Subject: Palo Verde Nuclear Generating Station (PVNGS)
Units 1, 2 and 3
PVNGS Response to NRC ATWS Safety Evaluation
File: 90-056-026

APS CLARIFICATIONS

NRC ATWS SAFETY EVALUATION

FIGURE 1

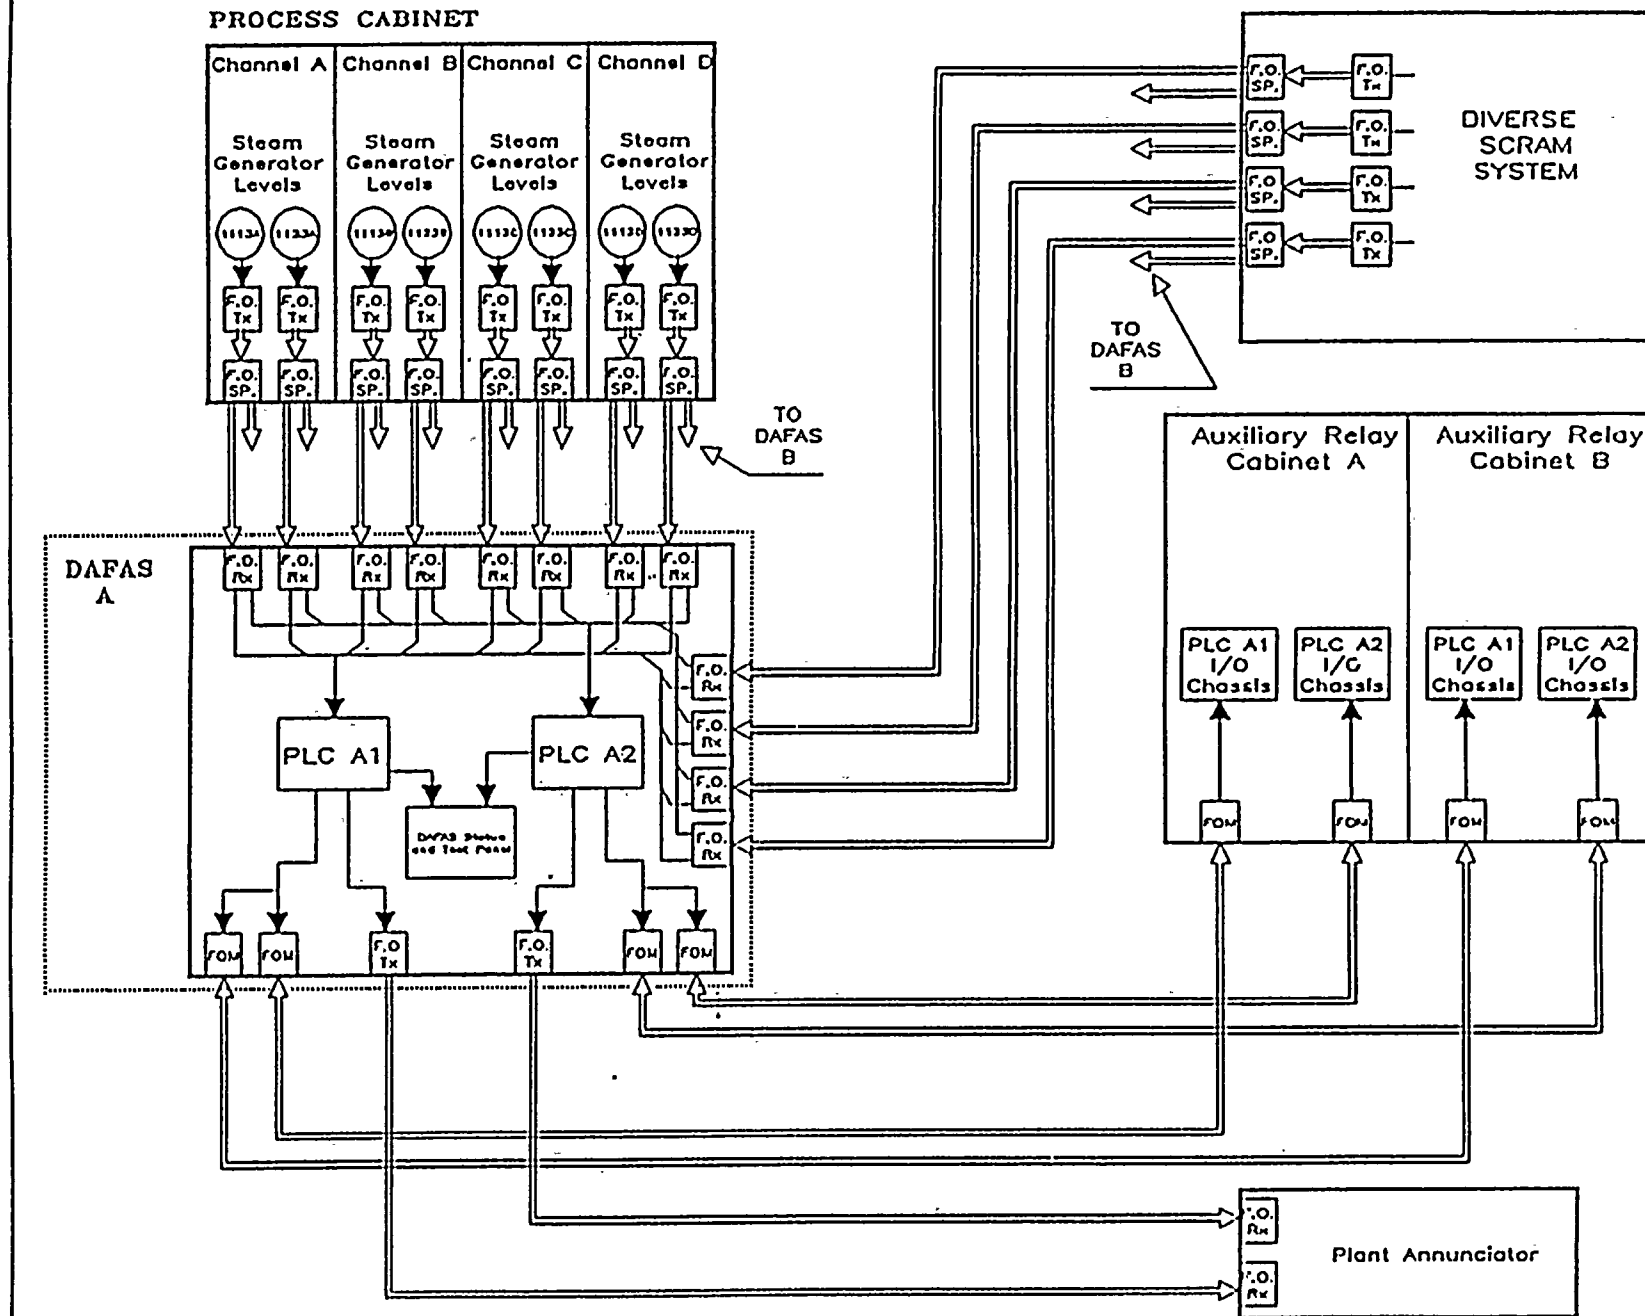
APS has reviewed the staff's Safety Evaluation, as provided in Reference 1, and has a number of clarifications. The attachment to this letter provides the details of these clarifications. The clarifications include the significant changes to the DAFAS design from the conceptual design, as previously provided in Reference 2. Figures 1 and 2 provide the DAFAS updated system diagram and hardware configuration, respectively.
